Hi-Fi Products
Service Bulletin

Model: TC-FX6/-FX1010/-K555/-555ES

No. 185

Subject: New Motor Does Not Turn

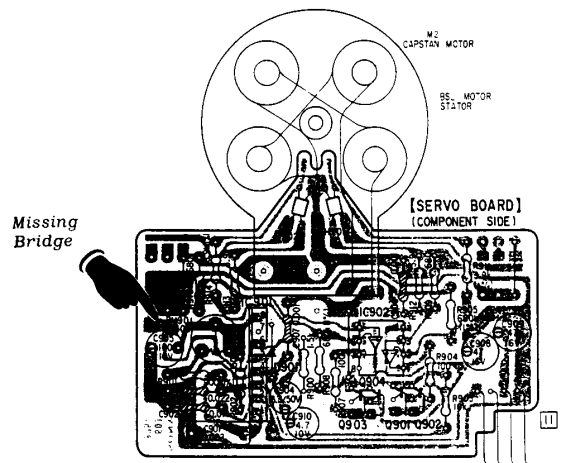
Symptom:
(61)

After replacing the capstan motor M2 (P/N X-3575-308-0), the motor does not move upon power up.

Solution: A solder bridge is missing. Replacing the bridge will solve the problem.
